HISTORIC AND DESIGN REVIEW COMMISSION

HDRC CASE NO: 2023-216
ADDRESS: 403 GILLESPIE
LEGAL DESCRIPTION: NCB 1745 BLK 8 S 51.5 FT OF 5 & 6 ARB A7
ZONING: R-6, H
CITY COUNCIL DIST.: 1
DISTRICT: Tobin Hill Historic District
APPLICANT: EICHER DANIEL
OWNER: EICHER DANIEL
TYPE OF WORK: Roof replacement (shingle to metal)
APPLICATION RECEIVED: May 24, 2023
60-DAY REVIEW: July 23, 2023
CASE MANAGER: Claudia Espinosa

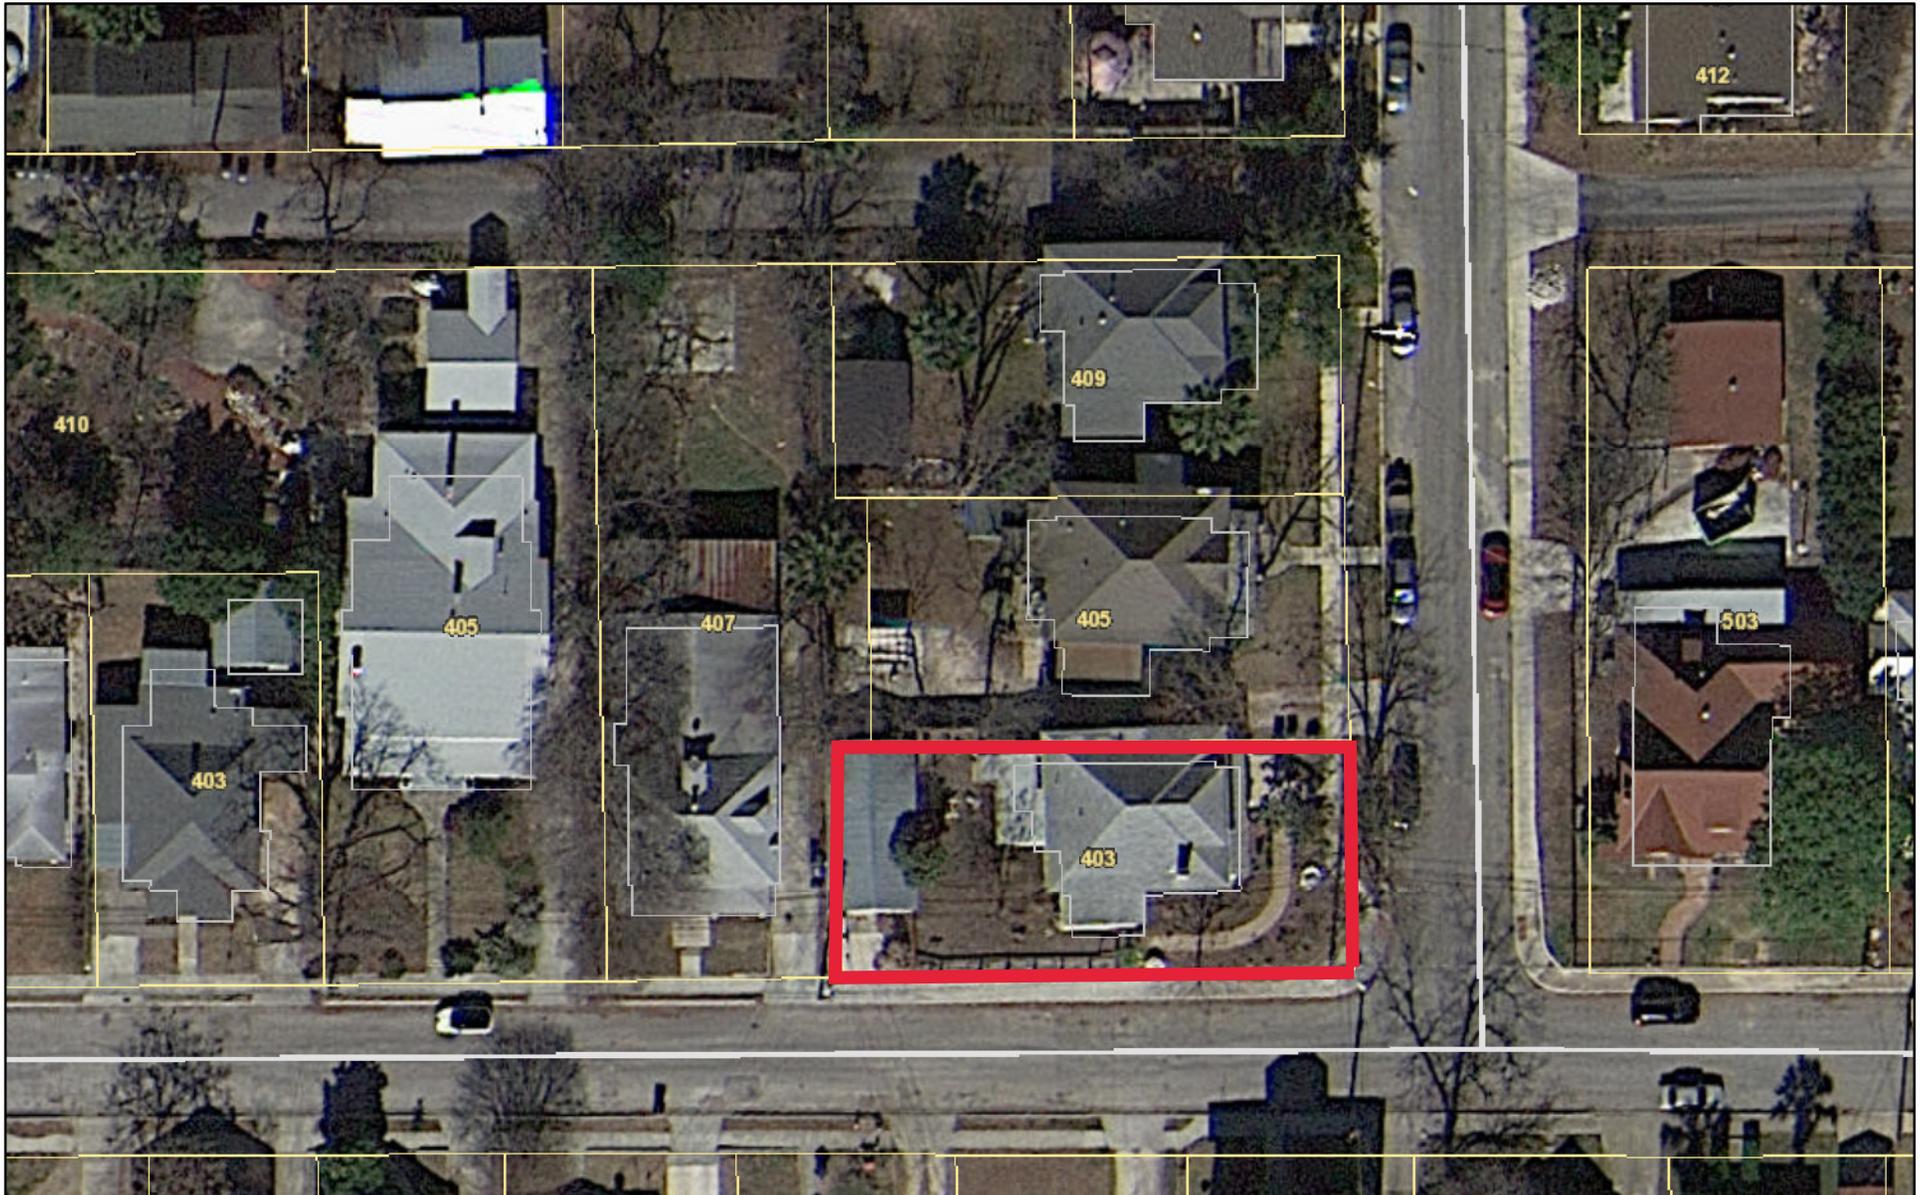
- a. The primary structure located at 403 Gillespie is a 2-1/2 story, single-family residence constructed circa 1910 in the Prairie style. The property first appears on the 1912 Sanborn Map. The home is situated on the corner of Gillespie and E Myrtle and features a hipped roof with a hipped front dormer, a full-width 1-story porch with

square columns, a prominent cream brick chimney on the south façade, and several paired or ganged windows. The property features a rear accessory structure constructed of a variety of wood cladding and a metal roof. The structure is contributing to the Tobin Hill Historic District.

- b. ROOF REPLACEMENT – The applicant has proposed to replace the existing shingle roof with a standing seam metal roof. Guideline 3.B.vi for Exterior Maintenance and Alterations states that metal roofs may be used on structures that historically had a metal roof or where a metal roof is appropriate for the style or construction period. The 1912 Sanborn Map shows that the roof originally featured a shingle roof, indicating the roofing material has not been altered, and a metal roof over the porch section. Staff finds that the standing seam metal roof installation is appropriate for the architectural style of this structure and is consistent with the Guidelines.

- i. That the applicant installs a standing seam metal roof featuring panels that are 18 to 21 inches wide, seams that are 1 to 2 inches high, a crimped ridge seam, and match the current finish or a standard galvalume finish. Panels should be smooth without striation or corrugation. Ridges are to feature a double-munch or crimped ridge configuration; no vented ridge caps or end caps are allowed. All chimney, flue, and related existing roof details must be preserved. An inspection must be scheduled with OHP staff prior to the start of work to verify that the roofing material matches the approved specifications. No modifications to the roof pitch or roof form are requested or approved at this time.
